SUBJECT: Sumter Electric Cooperative, Inc. - Major Development – Preliminary Plans for Substation Expansion – SR 44/Wildwood (Staff recommends approval).

REQUESTED ACTION: Approve Preliminary Plans for Sumter Electric Cooperative, Inc. Substation Expansion.

Sumter County Submittal Set - Preliminary and Engineering Review

CO- 02 - 107

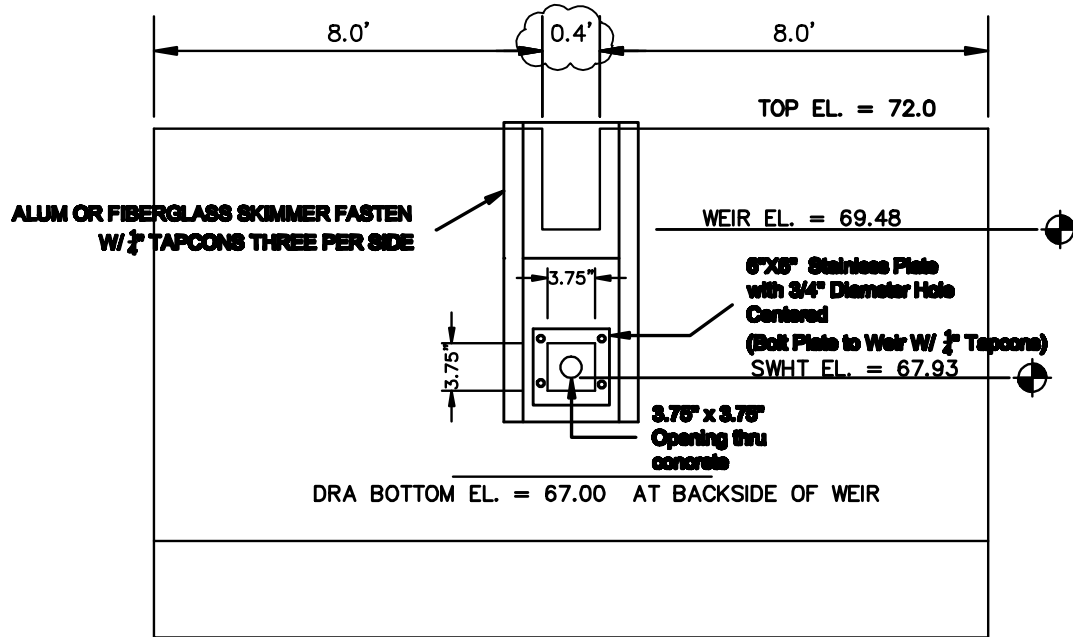
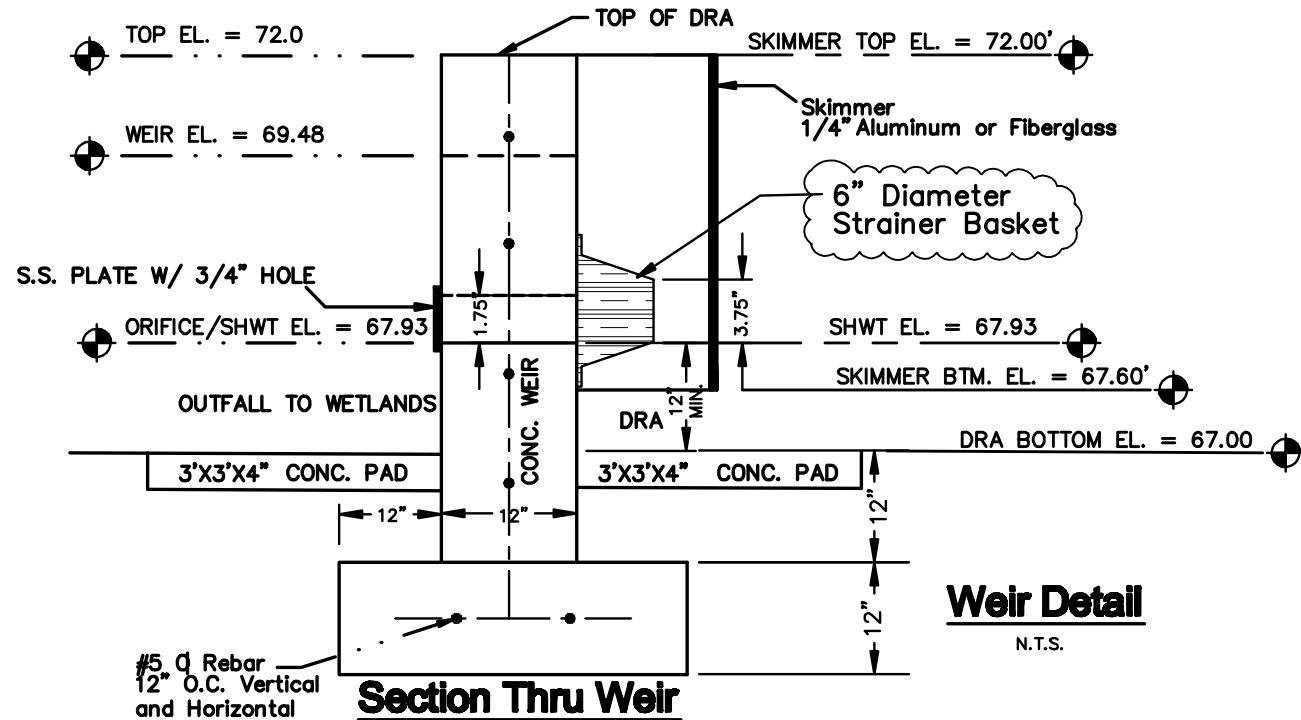
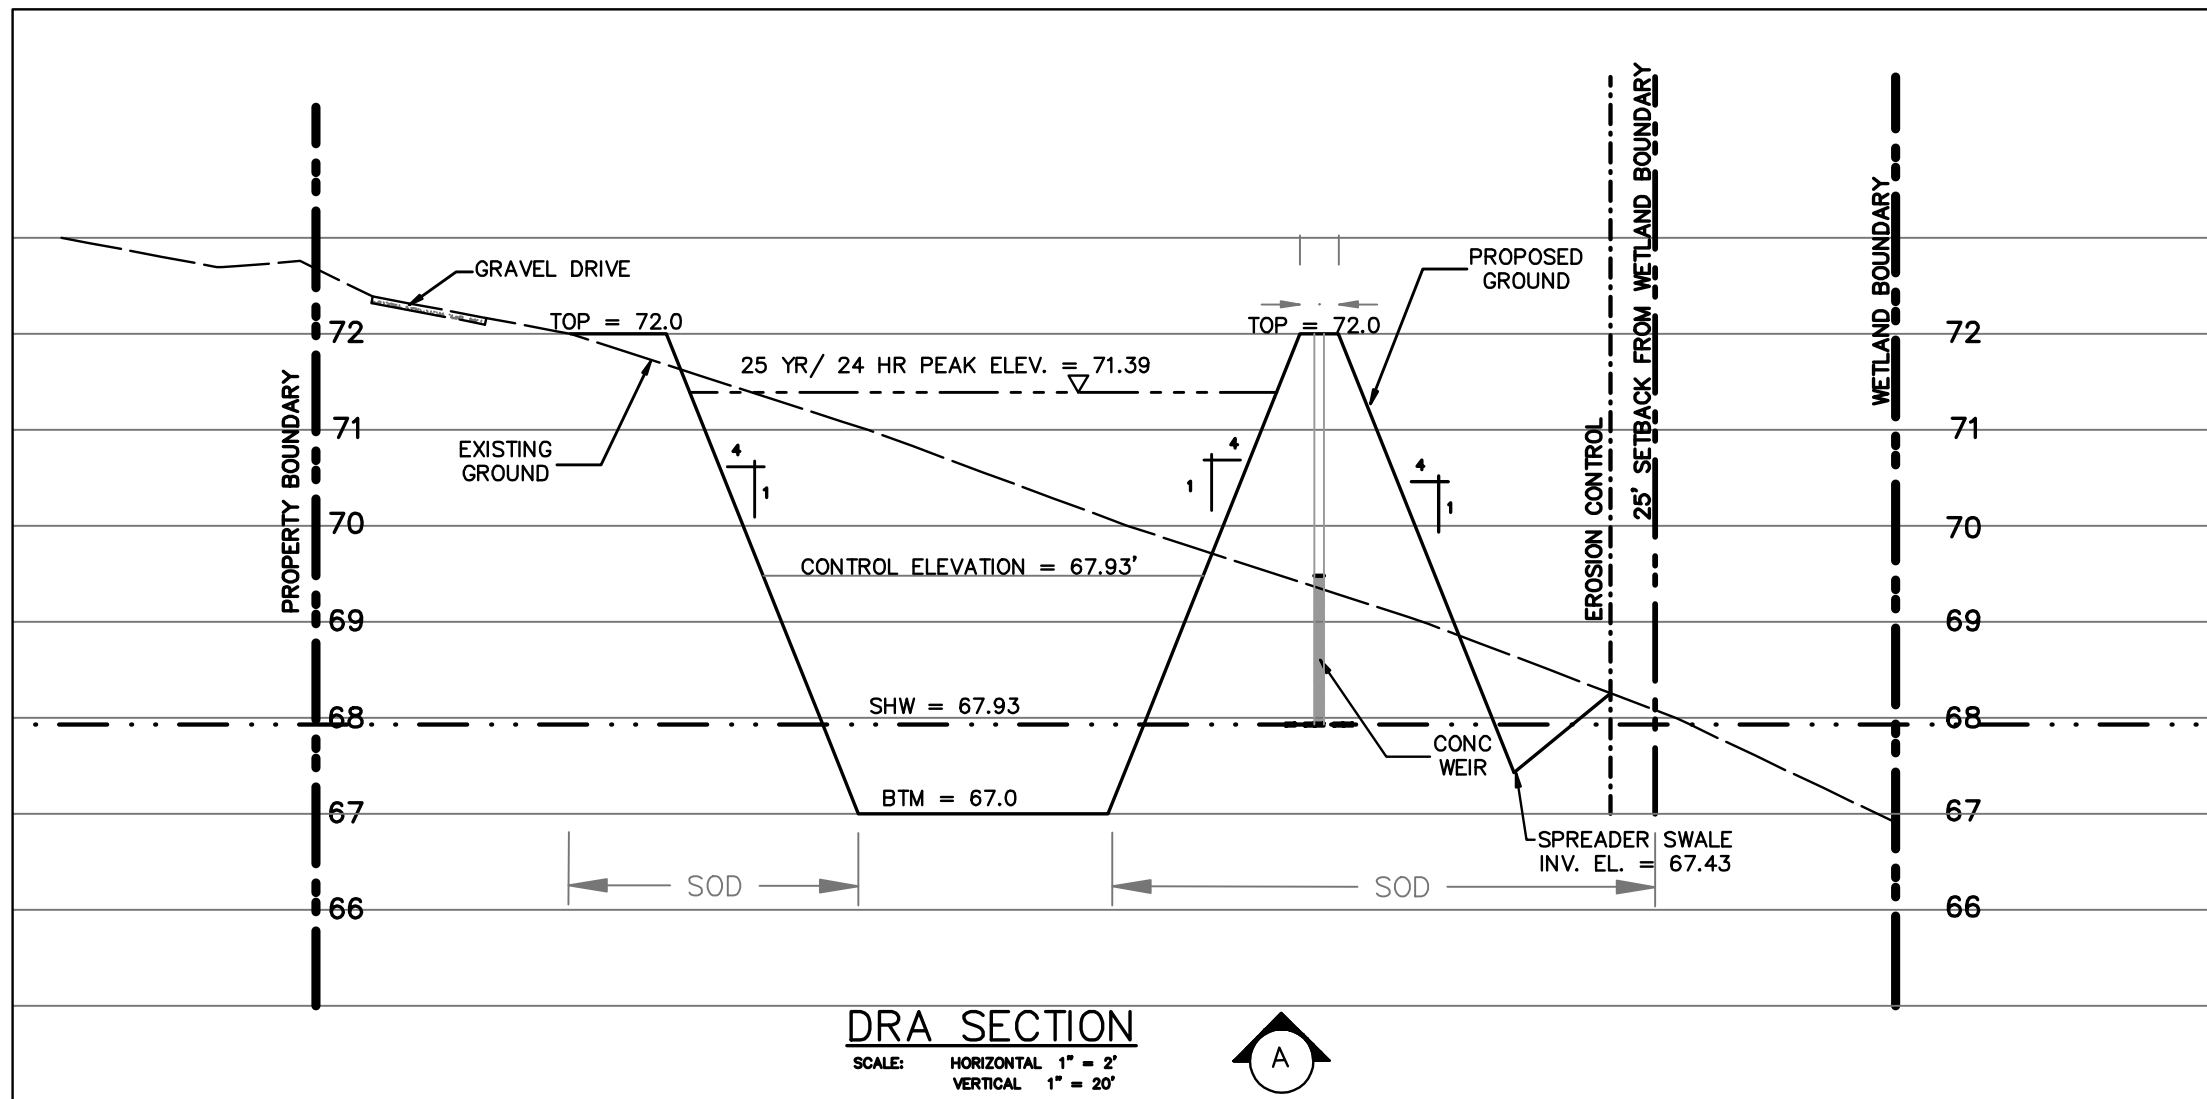
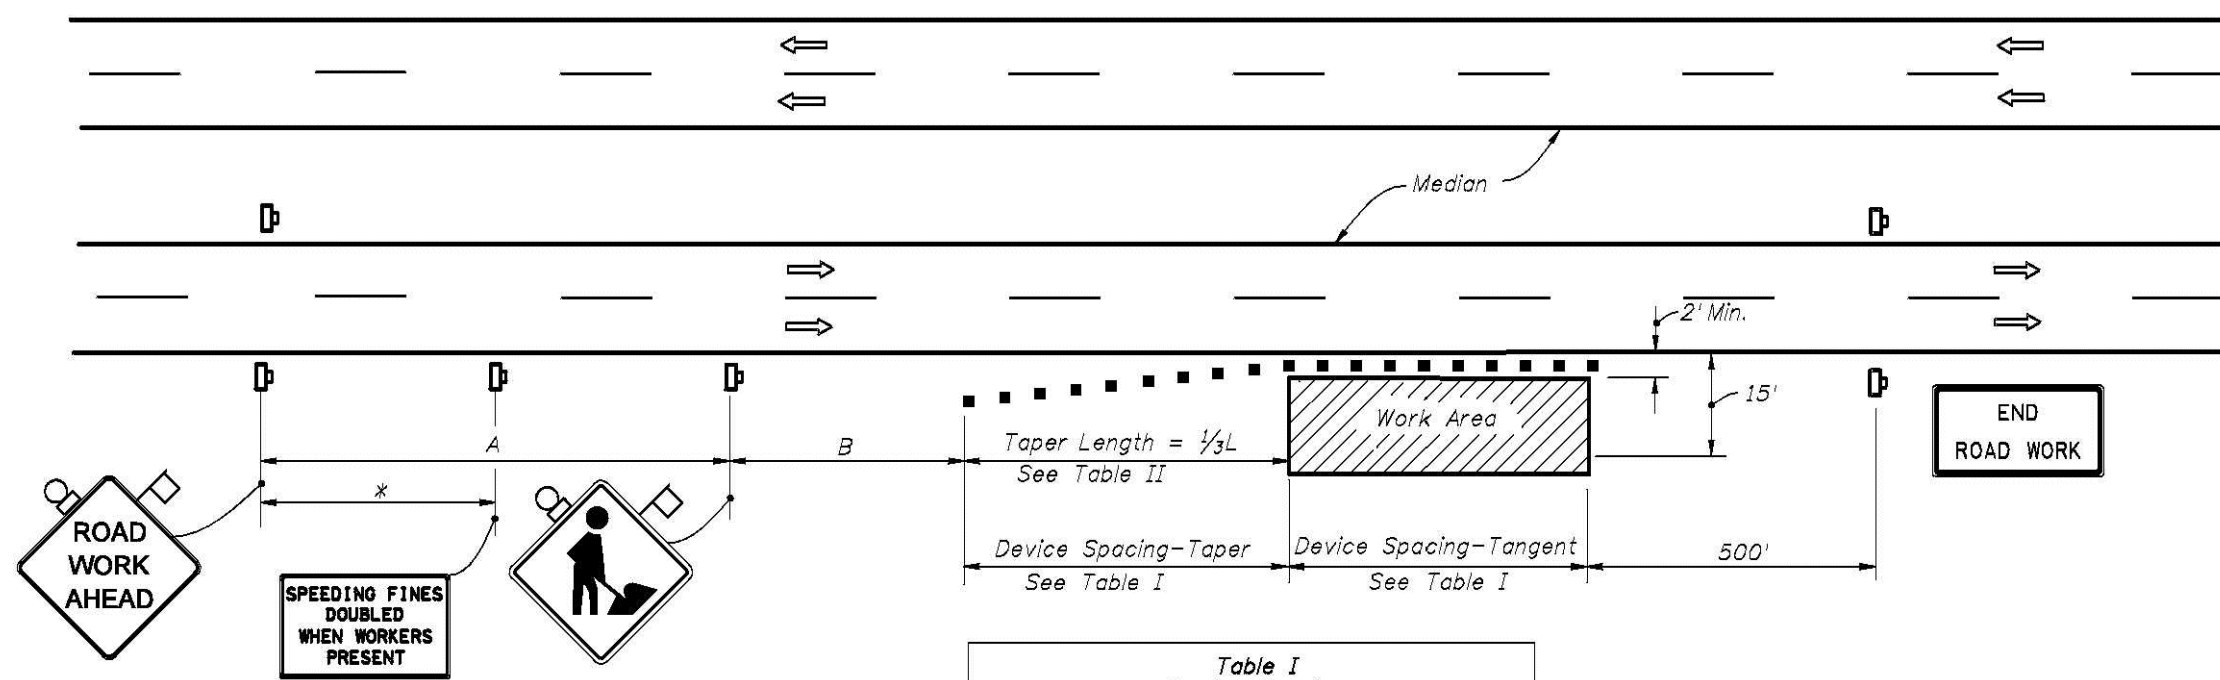
Revision:	BY:	Date:
1. REVISED PER FDEP COMMENTS	K.F.	4/28/10
2. REVISED ELEV. BTM SKIMMER, ADD EXIT'G BERM PER FDEP COMMENTS	D.F.S.	6/03/10
3. REVISED PER COUNTY COMMENTS	K.F.	7/12/10

8. As discussed in the TRC meeting, our experience has been that the turn down elbows actually encourage clogging and a strainer basket is more efficient and has been added to sheet 107.

9. The weir width has now been added to sheet 107 of the plans.
10. As discussed in the TRC meeting, the DRA is adjacent to a wetland which is conducive to the natural establishment of native vegetation. As such, no plantings (other than sod on the side slopes) are proposed in the DRA bottom. Out of an abundance of caution, I discussed this with the landscape architect on the project and he agrees with that approach.
